HAWAII HEALTH SYSTEMS CORPORATION  
KAUAI REGION

ADDENDUM #2

TO: Potential Offerors  
FROM: Maia Guirao, Contract Manager  
RE: Solicitation Addendum #2 to RFP #24-01/Renovation for CAH Beds

PATIENT ROOM & PHARMACY ADDITION

JOB NO. -  
 SHEET **S2.1** DATE January 30, 2024  
 OF - SHTS

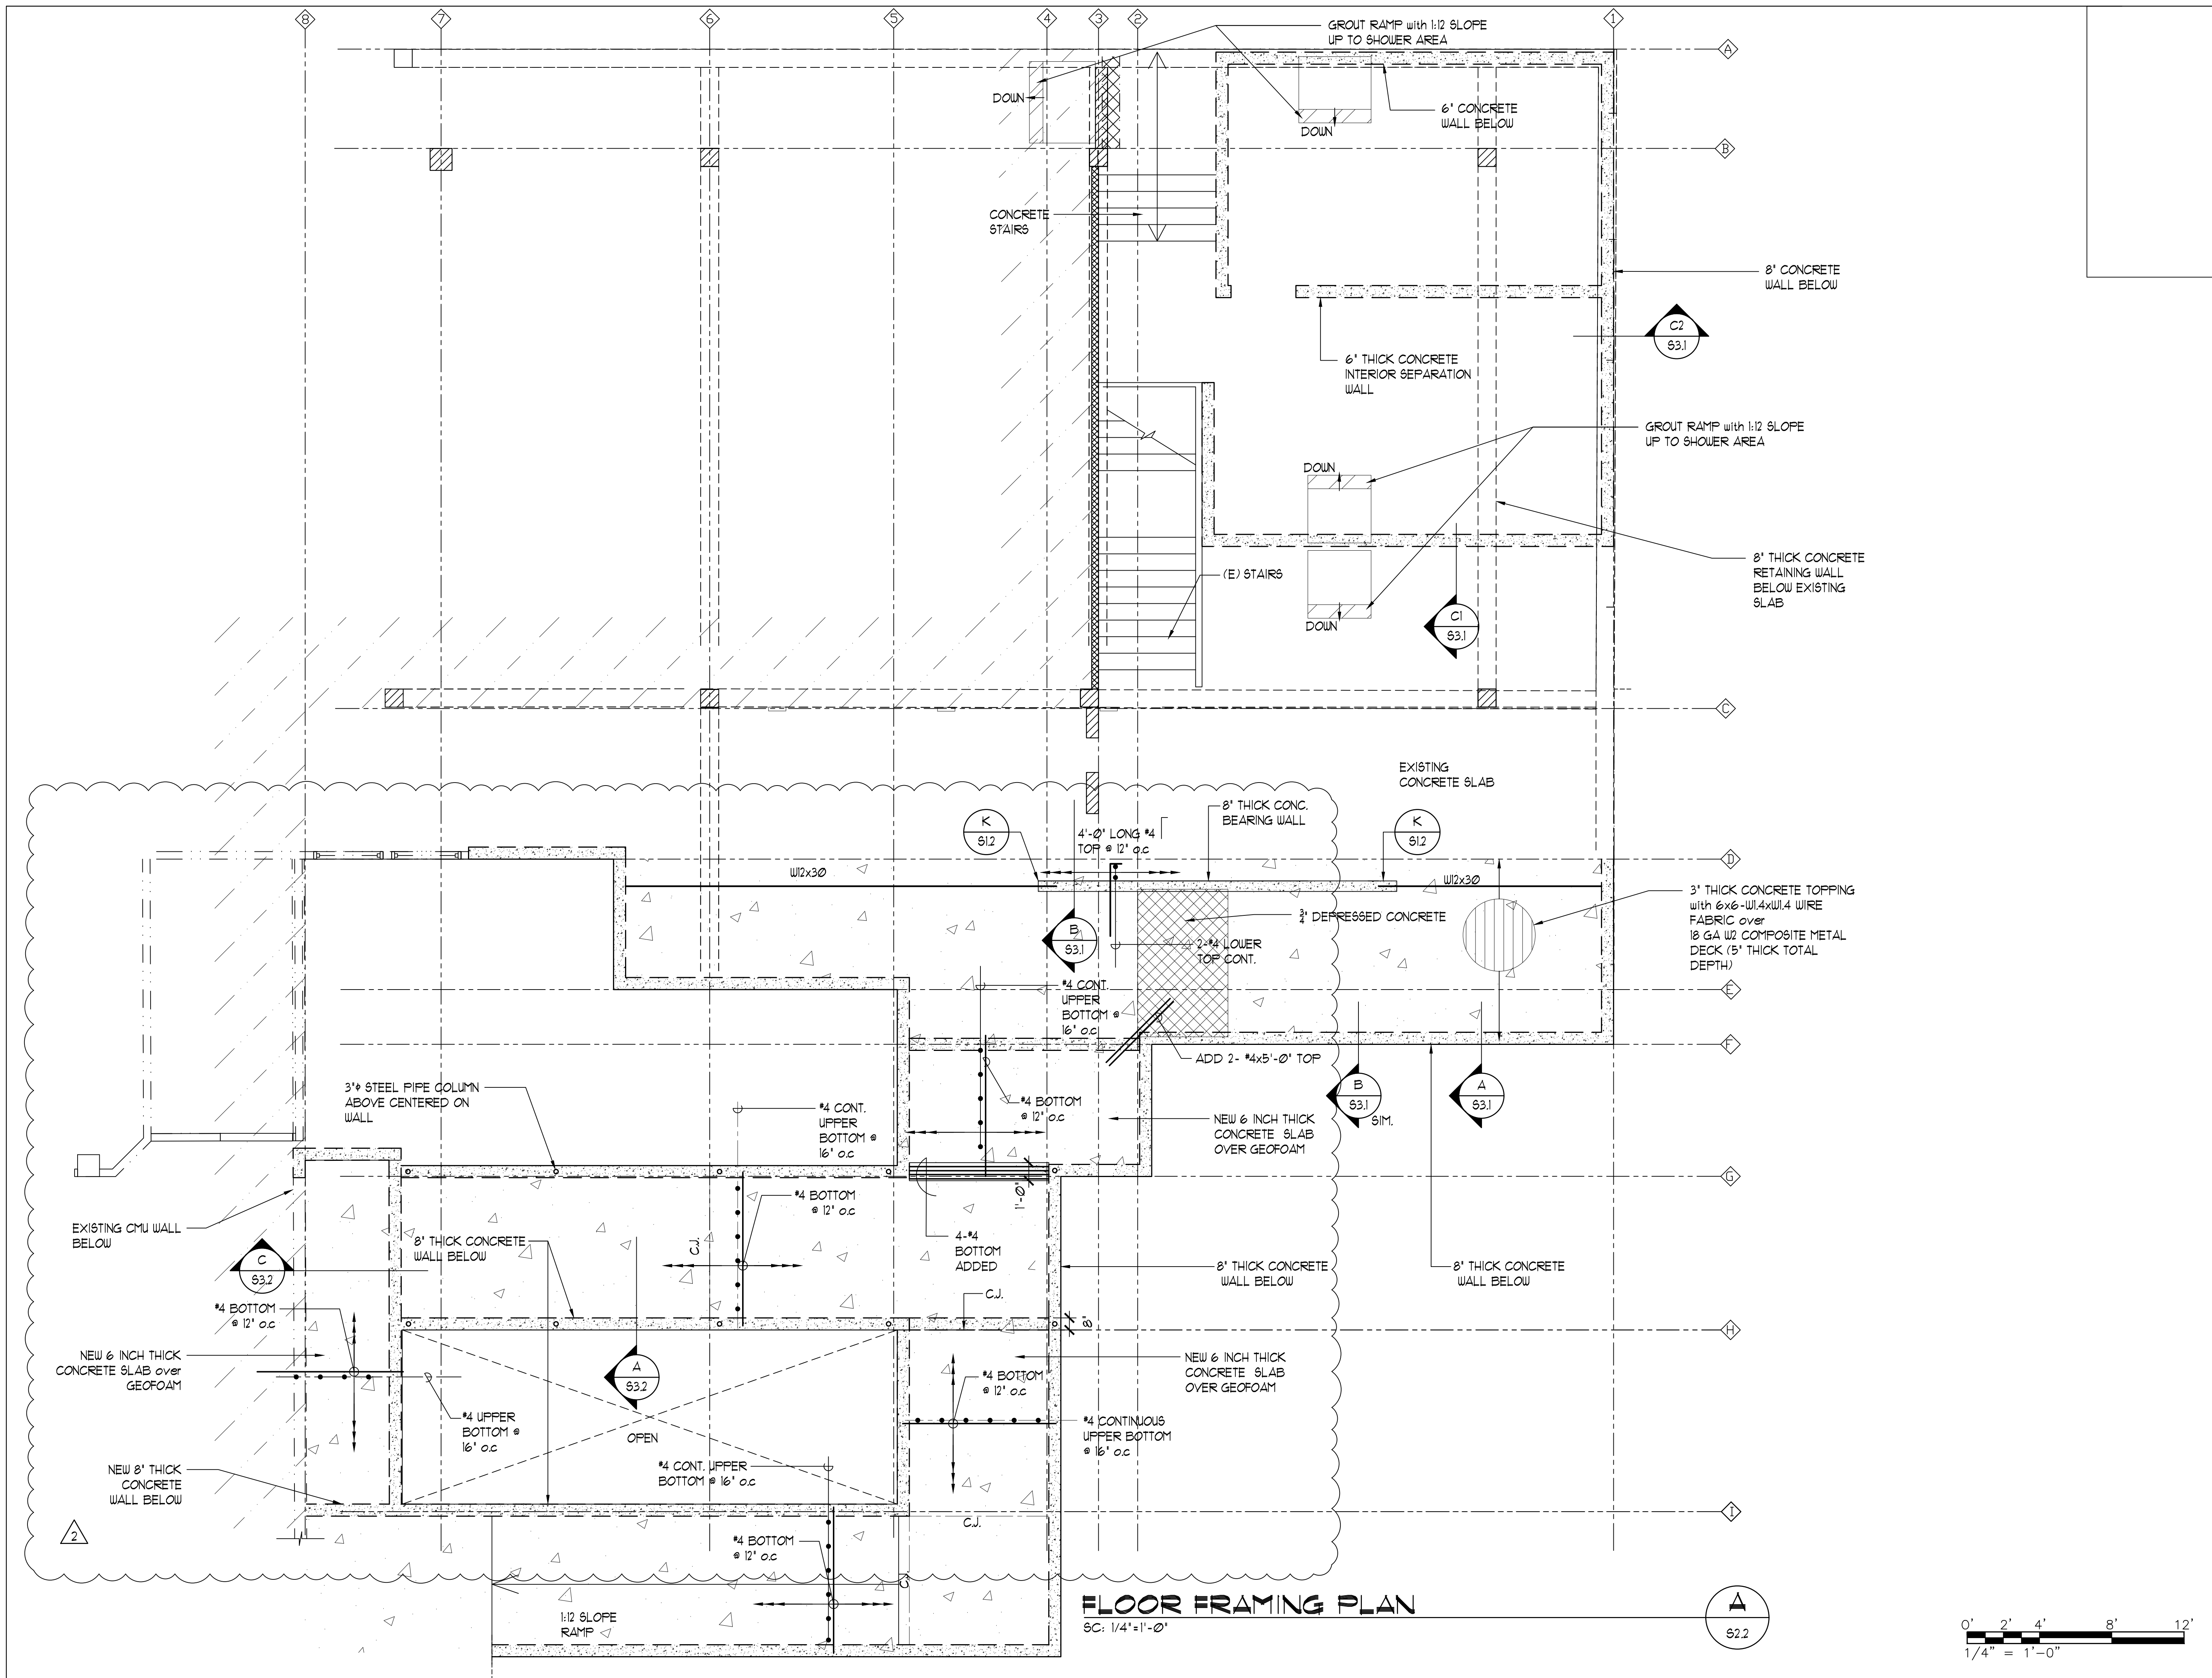
1. Revised structural drawings that show the area where the unit connects to the existing Emergency Department **2 Structural Revision 4.2.24** were provided for your reference.
2. Timetable has been updated as follows:
